McCULLOCH SERVICE BULLETIN

NO. 1601

MODEL 1. Mini Mac 25, 30, and 35
2. Mini Mac Hedgetrimmer & Drill

SUBJECT 1. Air Filter Cover and Shroud Assembly for Mini Mac 25, 30, and 35.
2. Special Service Cylinders for Mini Mac Hedgetrimmer & Drill Attachment.

Figure 1.

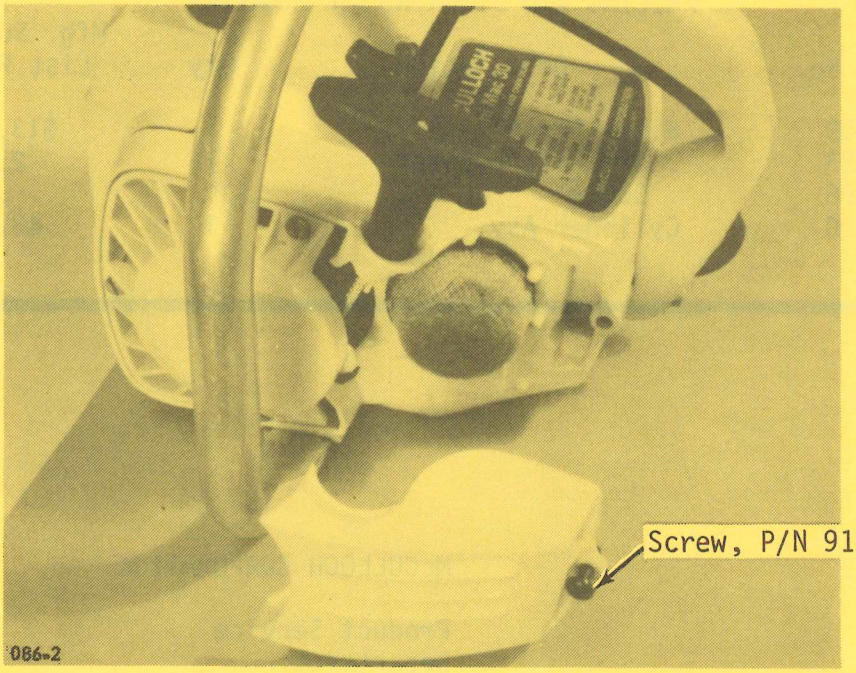
1 Mini Mac series chain saws are now being manufactured with a new Air Filter Cover, P/N 91853, which is secured to the shroud with a Screw, P/N 91796 (See Figure 1).

This method of securing the air filter cover, rather than with the previously used wire retainer, results in a tighter fitting air filter.

The models affected by this change and the serial numbers where the change took effect are listed below.

The older style shroud, P/N 88567, which used the wire retained air cleaner cover, will be replaced by Shroud Kit, P/N 91859, which consists of the new shroud and new air cleaner cover.

The older style Air Filter Cover, P/N 90393, and Retainer, P/N 83883, will continue to be available as service parts.
